# CLASS I SERVICE INSTRUCTIONS

No. 1135  
ATA Code 27-30

**SUBJECT:** FLIGHT CONTROLS - REPLACEMENT OF THE ELEVATOR CONTROL ARM BUSHINGS

**EFFECTIVITY:** BEECHCRAFT Skipper 77, serials WA-1 through WA-59.

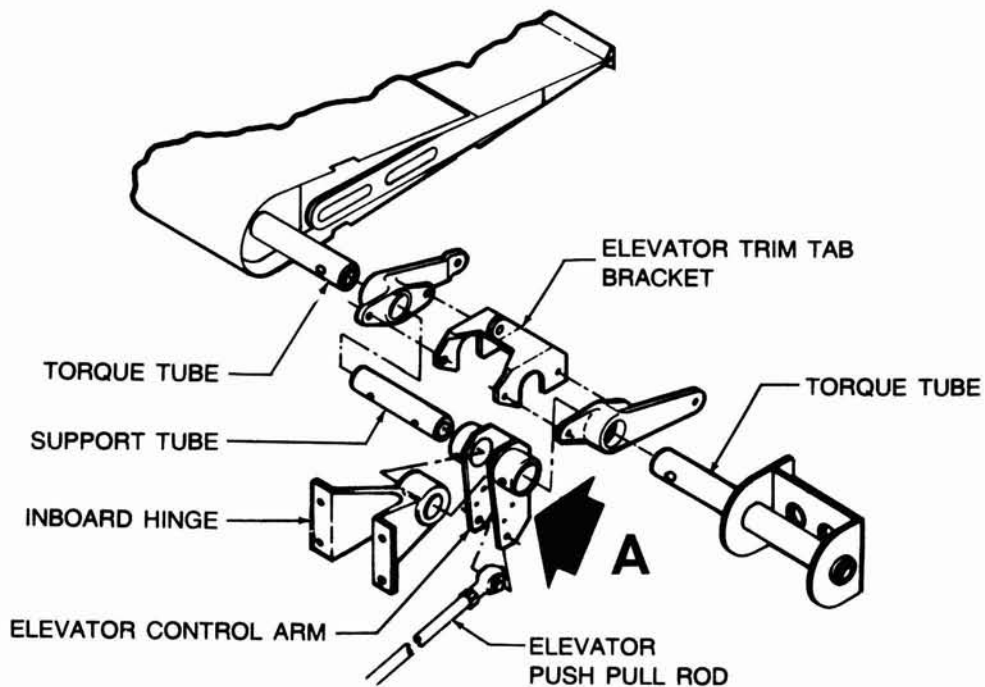
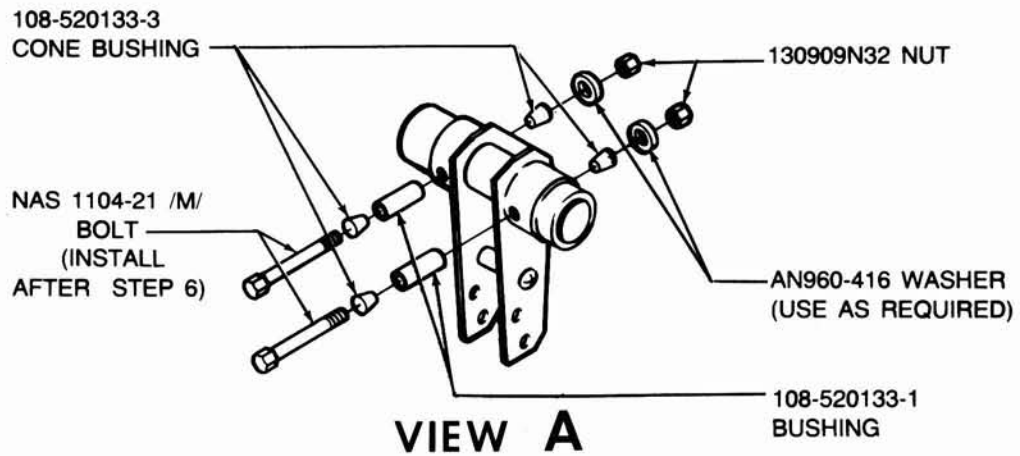
**REASON:** To reduce the possibility of free play in the elevator control arm assembly.

1. Remove the aft horizontal stabilizer fairing.
2. Remove and discard the two bolts, washers and nuts which connect the elevator torque tubes to the left and right side of the elevator control arm assembly.
3. Use the two new 108-520133-1 bushings to push out the original bushings which protected the bolts removed in Step 2. This will leave the new bushings in place without disturbing the alignment of the tubes and control arm assembly (see illustration, view A).
4. Insert the 108-520133-3 cone bushings and NAS1104-31 /M/ bolts in the 108-520133-1 bushings (see illustration, view A).

5. Install a 130909N32 nut on each NAS1104-31 /M/ bolt, using AN960-416 washers as necessary to keep the nuts on the threaded portion of the shafts. Tighten the nuts, adding washers as necessary, until the cone bushings are pressed in place and all free play between the torque tubes, support tube and control arm has been eliminated.

7. Install two NAS1104-21 /M/ bolts in place of the bolts removed in Step 6, add AN960-416 washers as necessary, and install new 130909N32 nuts on the bolts. Torque the nuts to 75-100 inch-pounds.
8. Recheck the elevators to ensure that there is no free play present, and reinstall the aft horizontal stabilizer fairing.
